Reversed Steering Control Cables – Thruster R33 and R45 Models

This is a revision of Outboard Service Bulletin 90-13. Destroy Bulletin 90-13 and insert Bulletin 90-13A. Revisions are underlined.

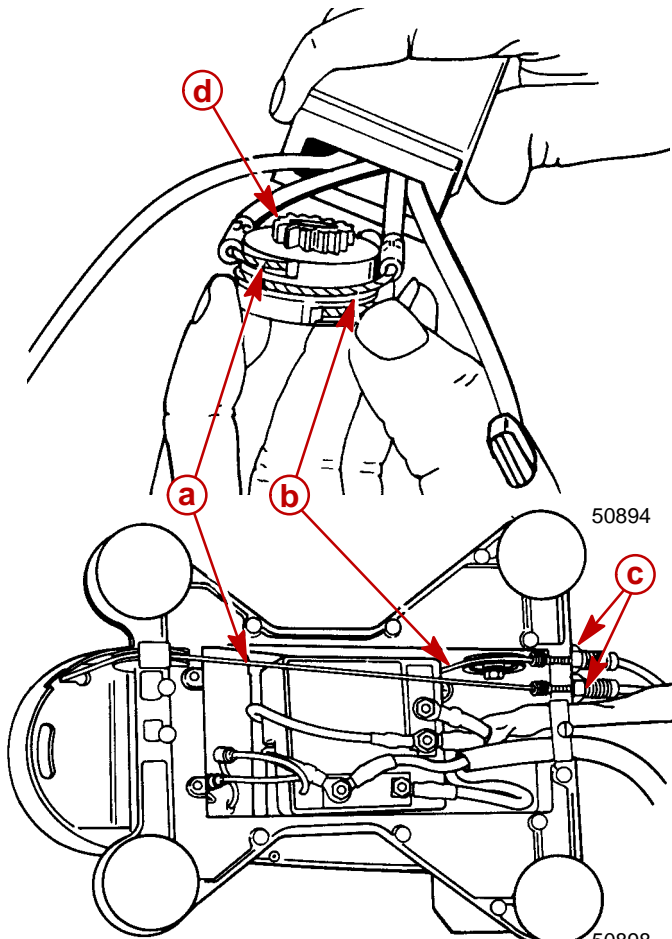
1. Remove direction indicator and control housing cover.
2. Remove retainer plate, idler gear and direction indicator gear.
3. Remove cable retainer and lift cable drum off vertical shaft.

- a - Retainer Plate
- b - Idler Gear
- c - Direction Indicator Gear
- d - Cable Retainer
- e - Cable Drum

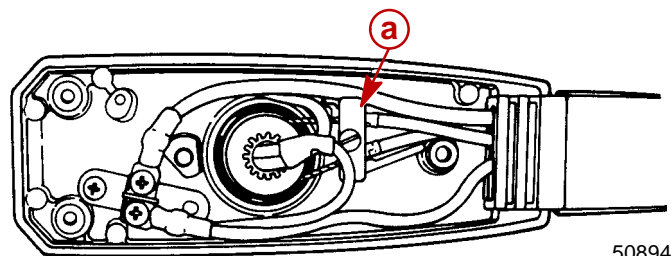
- Thread adjustment nuts all the way up on control cables.
- Reinstall control cables around cable drum as shown.

- a** - Control Cable (extends to heel of foot control plate) - Insert ball of cable into top socket on cable drum and wrap cable clockwise around drum
- b** - Control Cable (extends to toe of foot control plate) - Insert ball of cable into bottom socket on cable drum and wrap cable counterclockwise around drum
- c** - Adjustment Nuts
- d** - Cable Drum

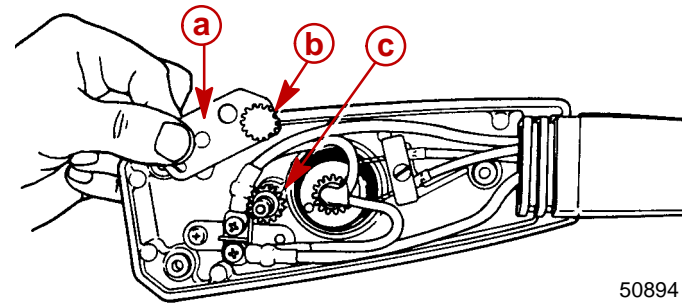
- Position motor in desired direction vs. desired angle of foot pedal. Place cable drum on vertical shaft and secure cable ends with cable retainer.

- a** - Cable Retainer

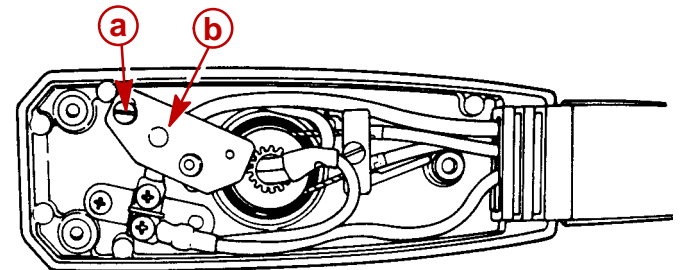
- Reinstall direction indicator gear, idler gear and retainer plate.

- a** - Retainer Plate
- b** - Idler Gear
- c** - Direction Indicator Gear

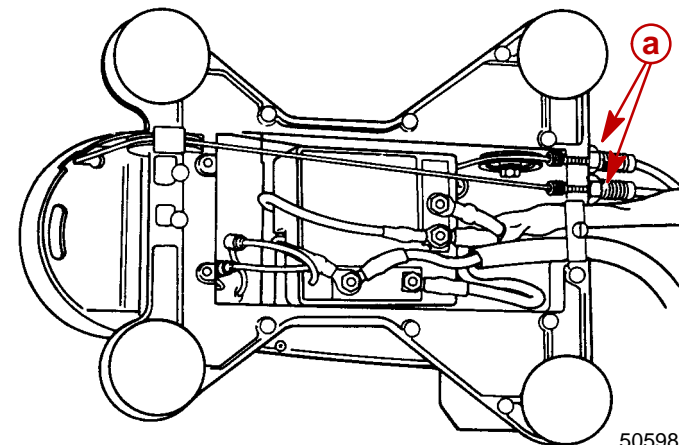
- Adjust retainer plate so gears turn smoothly.

- a** - Screw
- b** - Retainer Plate
